Access Audit Site Report

Pedernales Falls State Park
2585 Park Rd 6026
Johnson City, TX 78636
Accessibility Evaluation
Inspection Date: 02/08/2022
Inspectors: Tanya Scheibe

**TEXAS PARKS AND WILDLIFE DEPARTMENT
PEDERNALES FALLS STATE PARK**

**AMERICANS WITH DISABILITIES ACT COMPLIANCE INITIATIVE
PROGRAM AND POLICY REPORT
JULY 28, 2023**

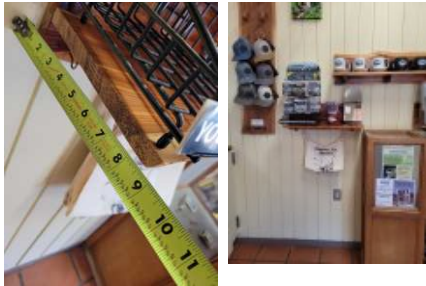
Finding Number	Area Description	Lat/Long	Finding	As Built	Recommendation	Citation	Photos	Figure
4	Exterior : Exterior Accessible Route	[30.3251286 , -98.255832]	The route of travel at this location does not provide the required minimum width. The minimum clear width for sidewalks and walks is 36 inches.	27.5" width into bird blind closer to stables	Widen EAR to min 36" clear width	2015 ABAAS Section: 403.5.1 2012 TAS Section: 403.5.1 2010 ADAS Section: 403.5.1

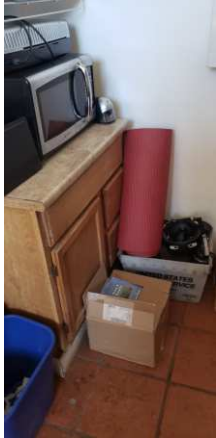
Finding Number	Area Description	Lat/Long	Finding	As Built	Recommendation	Citation	Photos	Figure
5	Headquarters (HQ) : HQ - Parking and Exterior Accessible Route	[30.30802, -98.25768]	Element meets all standards and requirements	HQ - 4 employee spaces, 6 standard, 1 accessible	None	2010 ADAS Section: N/A		
6	Headquarters (HQ) : HQ - Parking and Exterior Accessible Route	[30.30802, -98.25768]	The access aisle is not a minimum 5 feet wide. A car accessible parking stall's access aisle must be a minimum of 5 feet wide measured from centerline to centerline. Where the access aisle is not adjacent to another parking space or access aisle, measurements shall be permitted to include the full width of the line defining the access aisle.	HQ - 31" access aisle	Repaint access aisles to be 5' each	2015 ABAAS Section: 502.3.1 2012 TAS Section: 502.3.1 2010 ADAS Section: 502.3.1

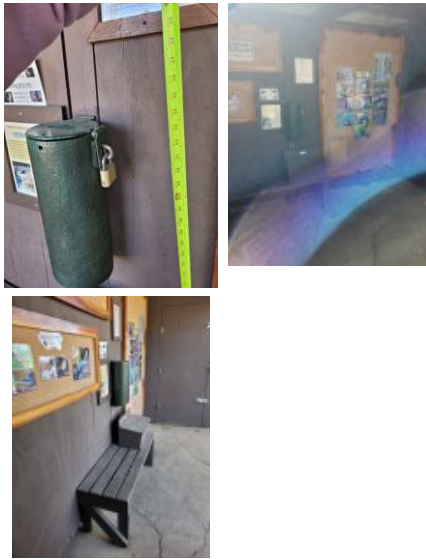
16	Headquarters (HQ) : HQ - Public Spaces	[30.30802, -98.25768]	An item or items project more than 4 inches into the circulation path. Wall-mounted objects that have leading edges between 27 inches and 80 inches from the floor must not project more than 4 inches into the circulation path. Protruding objects that extend to the floor or within 27 inches of the floor are cane detectable and are therefore not hazardous. Where it is necessary or desirable to have objects protrude from the wall, a manner of cane detection must be provided.	merchandise projects 9"	Relocate protruding objects or place cane detectable warning or bollard at foot of item.	2015 ABAAS Section: 307.2 2012 TAS Section: 307.2 2010 ADAS Section: 307.2

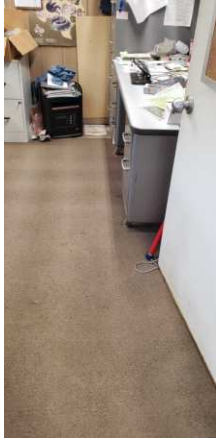
26	Park Site: Park Elements	[30.3249318 , -98.256269 2]	An accessible access route is not provided between elements, spaces and the facilities provided within the accessible camping unit. At least one outdoor recreation access route shall connect accessible elements, spaces and facilities provided within camping units with mobility features.	no route to 2 of 2 picnic tables by star theater, no route to sign	Create AR with crushed and compacted stone or similar outdoor material to table and sign. Replace one table with one of an accessible design.	2015 ABAAS Section: F244.5.1

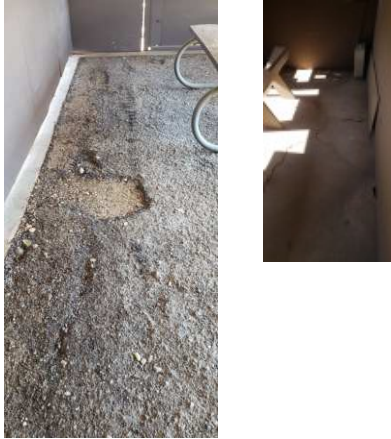
38	Park Site: Maintenance	[30.3189422, -98.2555128]	Spaces and elements within employee work areas shall only be required to comply with 206.2.8, 207.1, and 215.3 and shall be designed and constructed so that individuals with disabilities can approach, enter, and exit the employee work area. Employee work areas, or portions of employee work areas, other than raised courtroom stations, that are less than 300 square feet (28 m2) and elevated 7 inches (180 mm) or more above the finish floor or ground where the elevation is essential to the function of the space shall not be required to comply with these requirements or to be on an accessible route.	no route to car ports, law enforcement shed has 18" step entry, interpretive center has no route, 13" step up, knob no AR to picnic area by interpretive center	For employee spaces, relocate storage, furniture, and other obstacles at doorways to provide approach, enter and exit at the employee space. Provide an accessible route for access to employee buildings. Ramp steps at two door entries to max .25". Replace hardware with lever hardware or hardware operable without a tight pinch or grasp.	2015 ABAAS Section: F203.9 2012 TAS Section: 203.9 2010 ADAS Section: 203.9

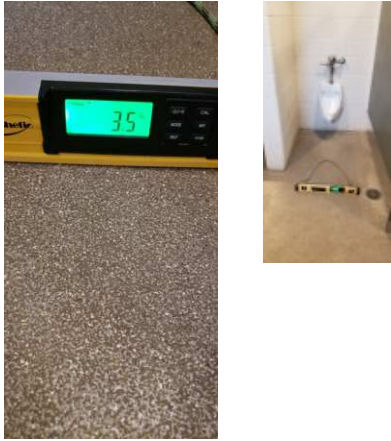
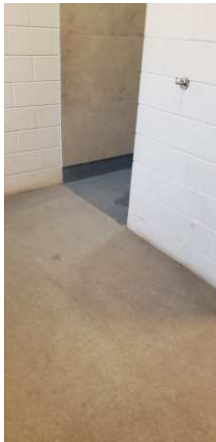
Finding Number	Area Description	Lat/Long	Finding	As Built	Recommendation	Citation	Photos	Figure
49	Park Site: Dump Station	[30.3128456 , -98.249582 4]	The surface of the clear ground space shall be firm and stable The slope of the clear ground space surface shall not be steeper than 1:48 in any direction. EXCEPTION: Where the surface is other than asphalt, concrete, or boards, slopes not steeper than 1:20 shall be permitted when necessary for drainage	deteriorated asphalt at dump station	Correct surface at the dump station to firm, stable and having max slope of 2.08% as a smart practice	2015 ABAAS Section: 1011.2.2, 1011.2.3, 1011.2 EXCEPTION

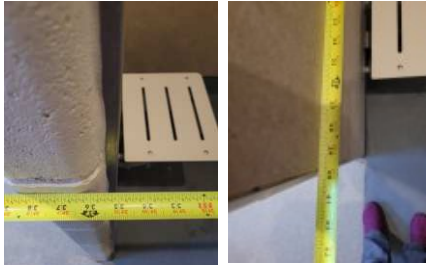
Finding Number	Area Description	Lat/Long	Finding	As Built	Recommendation	Citation	Photos	Figure
50	Camping Area - Site 63: Camping - Parking by Site 63 and Exterior Accessible Route	[30.3114193, -98.2475842]	Element meets all standards and requirements	restroom building by site 63 - 5 standard 1 accessible	None	2010 ADAS Section: N/A		
51	Camping Area - Site 63: Camping - Parking by Site 63 and Exterior Accessible Route	[30.31141, -98.2475734]	The cross slopes (narrow dimension) and/or running slopes (long dimension) of the access aisle exceeds 2%. The running slope and the cross slope in an accessible parking stall and the access aisle must not exceed 2%.	restroom building by site 63 - stall - 3.8% slope, 2.6% slope	Repair or correct slope of parking space and access aisle to max 2.08% in any direction.	2015 ABAAS Section: 502.4 2012 TAS Section: 502.4 2010 ADAS Section: 502.4		
52	Camping Area - Site 63: Camping - Parking by Site 63 and Exterior Accessible Route	[30.31141, -98.2475734]	The access aisle is not a minimum 5 feet wide. A car accessible parking stall's access aisle must be a minimum of 5 feet wide measured from centerline to centerline. Where the access aisle is not adjacent to another parking space or access aisle, measurements shall be permitted to include the full width of the line defining the access aisle.	restroom building by site 63 - 57" width	Repaint access aisles to be 5' each	2015 ABAAS Section: 502.3.1 2012 TAS Section: 502.3.1 2010 ADAS Section: 502.3.1

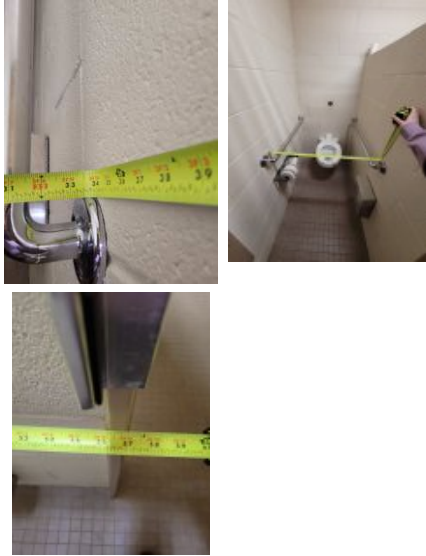
Finding Number	Area Description	Lat/Long	Finding	As Built	Recommendation	Citation	Photos	Figure
133	Trails: Trailhead	[30.3340823 , -98.252392]	There is no drinking fountain for standing persons. Spout outlets of drinking fountains for standing persons shall be 38 inches minimum and 43 inches maximum above the finish floor or ground.	Pedernales Falls trailhead - lacks fountain for standing person	Add second high bowl fountain for standing persons.	2015 ABAAS Section: 602.7 2012 TAS Section: 602.7 2010 ADAS Section: 602.7, 211.2		
134	Trails: Trailhead	[30.3344793 , -98.252846 7]	The surface of trails, passing spaces, and resting intervals shall be firm and stable	Pedernales Falls Trailhead - no accessible route to trailhead or sign, loose rock surface	Establish protocols for regular and frequent inspection and maintenance of accessible trail surface as a smart practice	2015 ABAAS Section: 1017.2

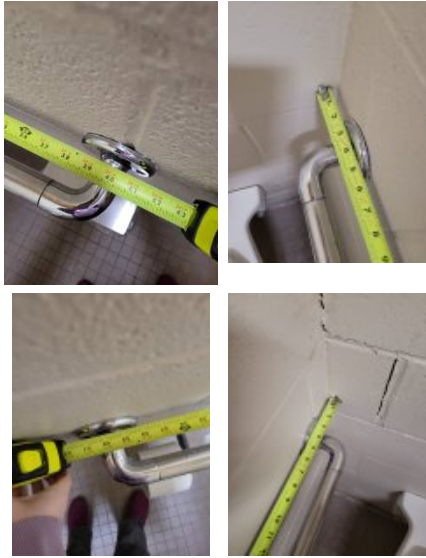
Finding Number	Area Description	Lat/Long	Finding	As Built	Recommendation	Citation	Photos	Figure
135	Trails: Trailhead	[30.3122806 , -98.244998 5]	The surface of trails, passing spaces, and resting intervals shall be firm and stable	Twin Falls Trail - no accessible route to trailhead or sign, loose rock surface	Establish protocols for regular and frequent inspection and maintenance of accessible trail surface as a smart practice	2015 ABAAS Section: 1017.2		
136	Trails: Trailhead	[30.3123084 , -98.245320 4]	The surface of trails, passing spaces, and resting intervals shall be firm and stable	trammel crossing river access trail - no accessible route to trailhead or sign, loose rock surface	Establish protocols for regular and frequent inspection and maintenance of accessible trail surface as a smart practice	2015 ABAAS Section: 1017.2

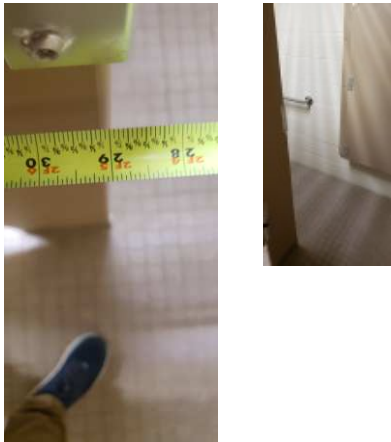
147	Trails: Pedernales Falls Trailhead - Women's Restroom	[30.3340811 , -98.25238]	The door must have a smooth surface within 10 inches of the floor on the push side. Swinging door surfaces within 10 inches of the finish floor or ground measured vertically must have a smooth surface on the push side extending the full width of the door. Parts creating horizontal or vertical joints in these surfaces shall be within 1/16 inch of the same plane as the other. All gates, including ticket gates, shall meet all applicable specifications for doors.	door has rust, toe hazard	Provide kick plate on push side of door from floor to 10" aff	2015 ABAAS Section: 404.2.10 2012 TAS Section: 404.2.10 2010 ADAS Section: 404.2.10

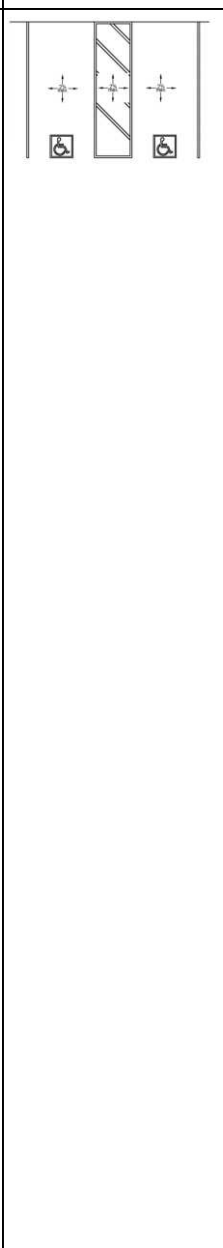
157	Trails: Pedernales Falls Trailhead - Men's Restroom	[30.3340892 , -98.252417 5]	The side grab bars are not in the correct location. Grab bars on the side wall must be installed so that the end closest to the rear wall is maximum 12" from the rear wall. The end furthest from the rear wall must be mounted minimum 54" from the rear wall.	mounted 40" from rear wall	Remount bars to max 12" from the rear wall at the close end and min 54" on the far end, and 33" to 36" aff. See previous finding for cost.	2015 ABAAS Section: 604.5.1 2012 TAS Section: 604.5.1 2010 ADAS Section: 604.5.1

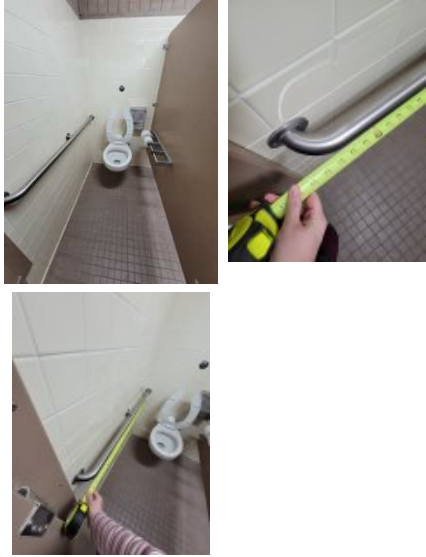
170	Beach Area: Beach - Parking and Exterior Accessible Route	[30.3138181 , -98.239420 9]	The access aisle is on the driver's side of the stall. Access aisles must be located on the passenger side of the stall for angled van accessible stalls.	picnic/ restroom parking by beach - access aisle on the driver side	Relocate access aisle to the passenger side of the stall	2015 ABAAS Section: 502.3.4 2012 TAS Section: 502.3.4 2010 ADAS Section: 502.3.4

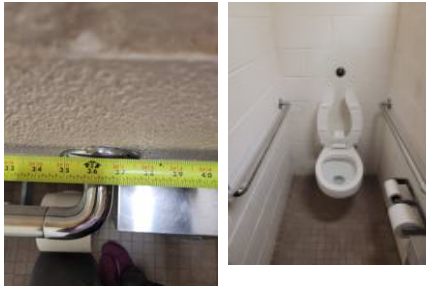
Finding Number	Area Description	Lat/Long	Finding	As Built	Recommendation	Citation	Photos	Figure
189	Beach Area: Beach - Men's Restroom Swimming	[30.313619, -98.239588 5]	The stall door fails to comply with all of the door requirements. The stall door must be a minimum of 32" wide and have compliant hardware on both sides. The stall door must be self-closing.	stall door - 29" wide	Widen stall doors to 32" when opened to 90 degrees	2015 ABAAS Section: 404.2.3, 404.2.7, 604.8.2.2 2012 TAS Section: 404.2.3, 404.2.7, 604.8.2.2 2010 ADAS Section: 404.2.3, 404.2.7, 604.8.2.2

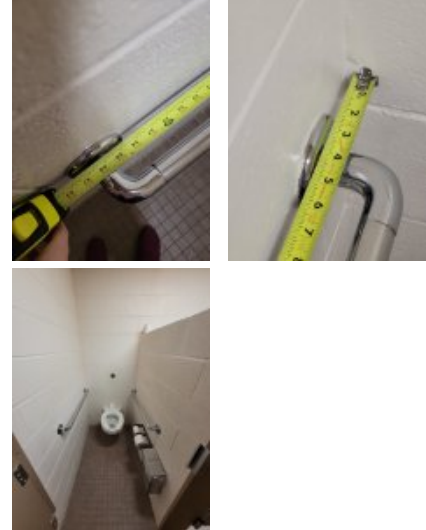
Finding Number	Area Description	Lat/Long	Finding	As Built	Recommendation	Citation	Photos	Figure
190	Beach Area: Beach - Men's Restroom Swimming	[30.3136236 , -98.239591 2]	Grab bars shall comply with 609. A side-wall grab bar complying with 604.5.1 shall be provided on both sides of the compartment. The space between the wall and the grab bar shall be 1½ inches (38 mm). The space between the grab bar and projecting objects below and at the ends shall be 1½ inches (38 mm) minimum. The space between the grab bar and projecting objects above shall be 12 inches (305 mm) minimum. Grab bars shall be installed in a horizontal position, 33 inches (840 mm) minimum and 36 inches (915 mm) maximum above the finish floor measured to the top of the gripping surface, except that at water closets for children's use complying with 604.9, grab bars shall be installed in a horizontal position 18 inches (455 mm) minimum and 27 inches (685 mm) max	side bars - 36" bars	Replace or add side grab bars with a 42" long grab bar, mounted max 12" from the rear wall at the close end and min 54" on the far end and 33" to 36" aff	2015 ABAAS Section: 604.8.2.3, 609.3, 609.4 2012 TAS Section: 609.4, 609.3, 604.8.2.3 2010 ADAS Section: 609.3, 609.4, 604.8.2.3
